**BIDDERS BULLETIN**

**PROJECT:** North Park Elementary School – 2012 Addition  
and Renovation  
Broken Bow, Nebraska

BB-3

**DATE ISSUED:** March 27, 2012

**02500-000**  
**POWR-TOUCH® SYSTEM**  
**ELECTRICAL WIRING DIAGRAM**

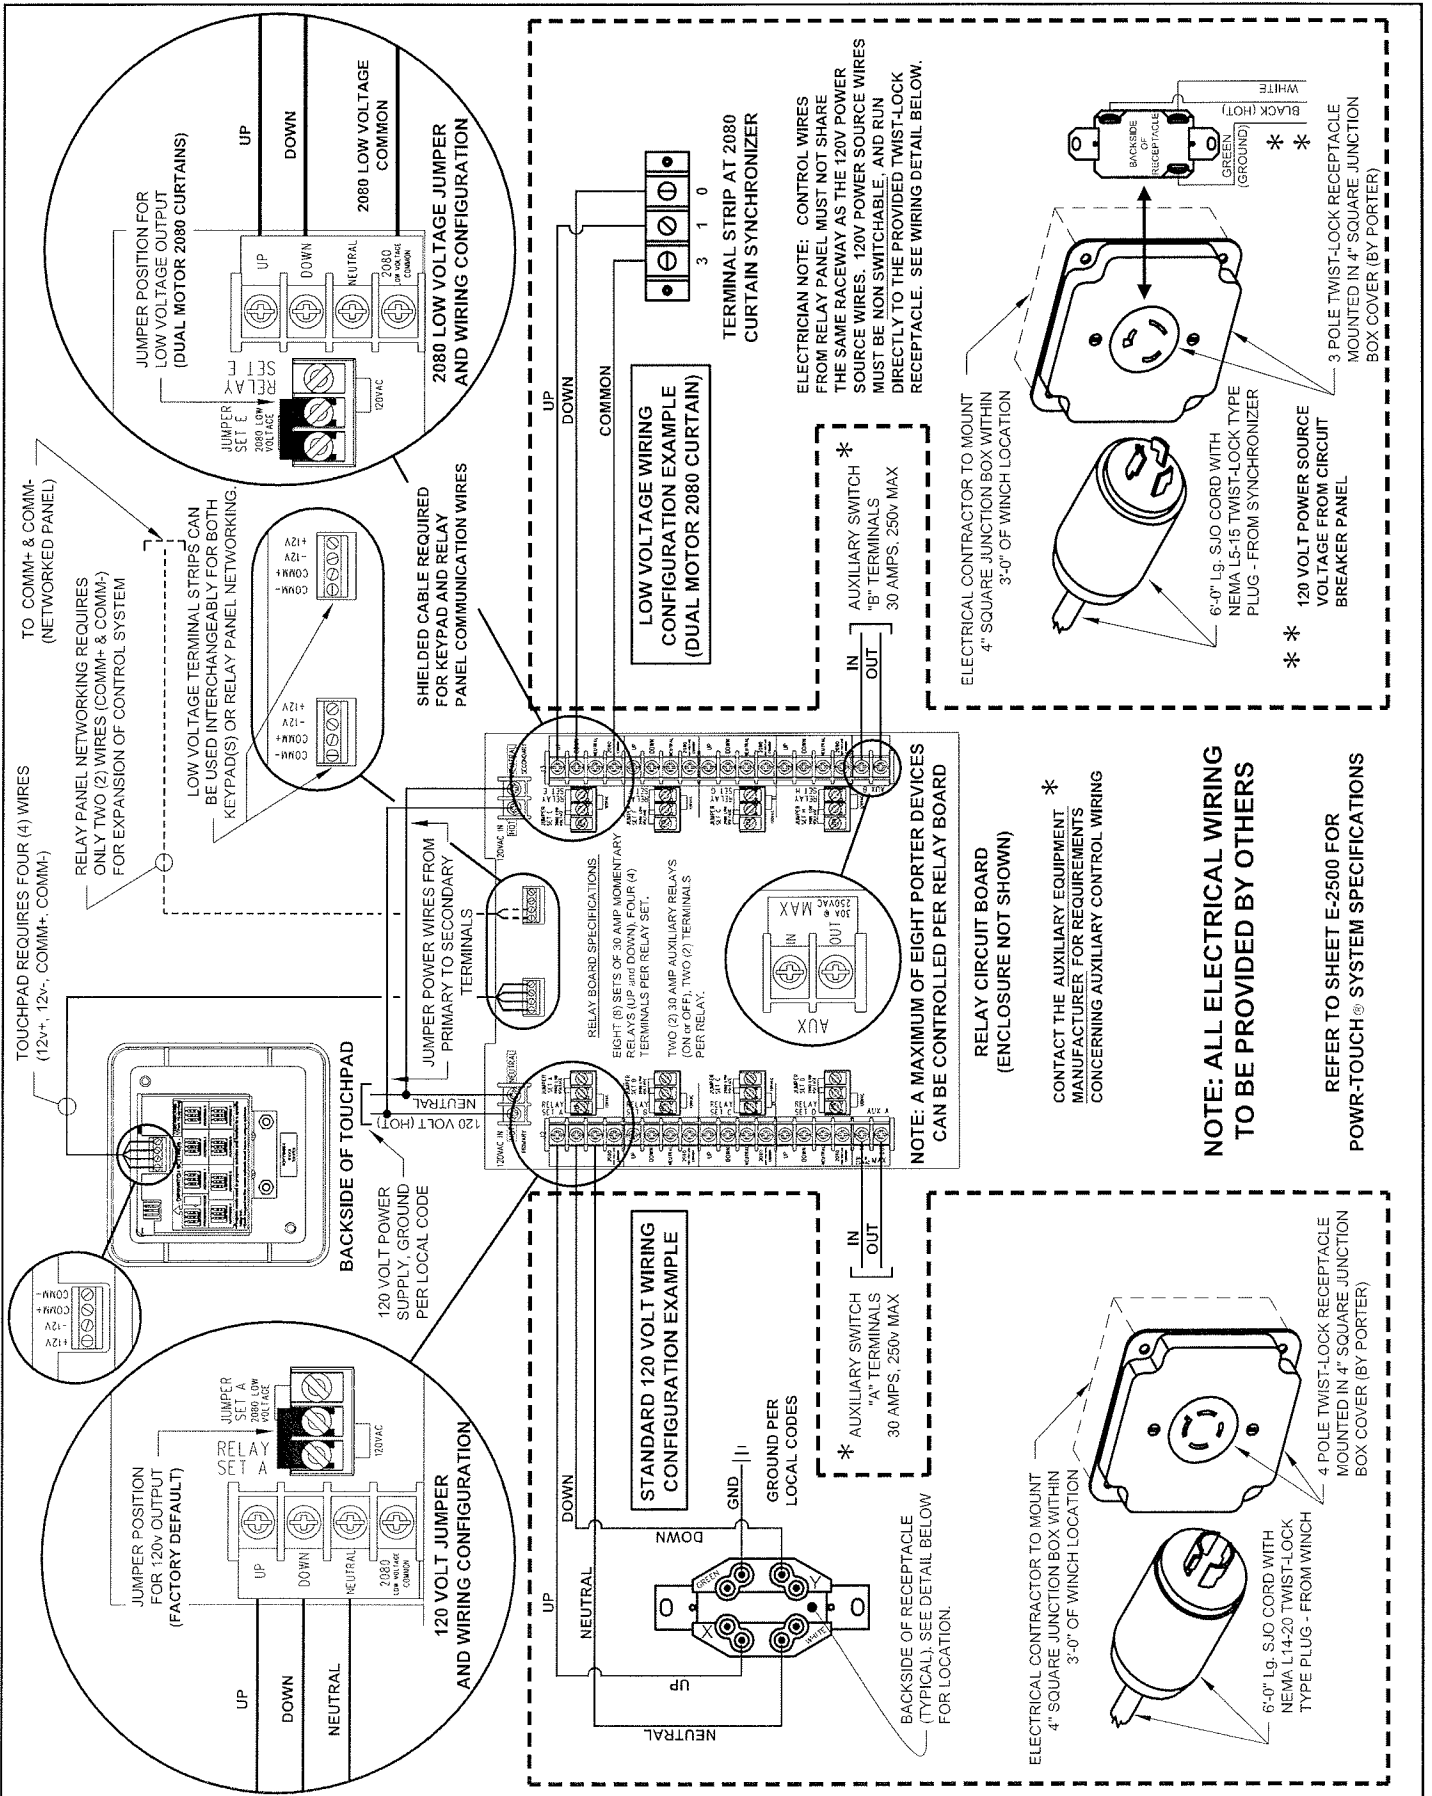
E. In Multi Purpose 147c delete the switches called out in Note 9. The goal controls shall be Porter 2500 Power Touch system provided by others. See Attached Porter Wiring diagram for details. One 120-volt circuit shall be installed to the control panel. This panel shall be installed in I.T./Electrical 153c. The keypad shall be installed where the deleted switches in Note 9 are shown. Circuits from the control panel shall be installed to each BB Goal and the Divider Curtain. Delete the individual 120-volt circuit shown to each BB Goal and Divider Curtain, power to these devices shall come from the one 120-volt circuit in the control panel, see attach wiring diagram.
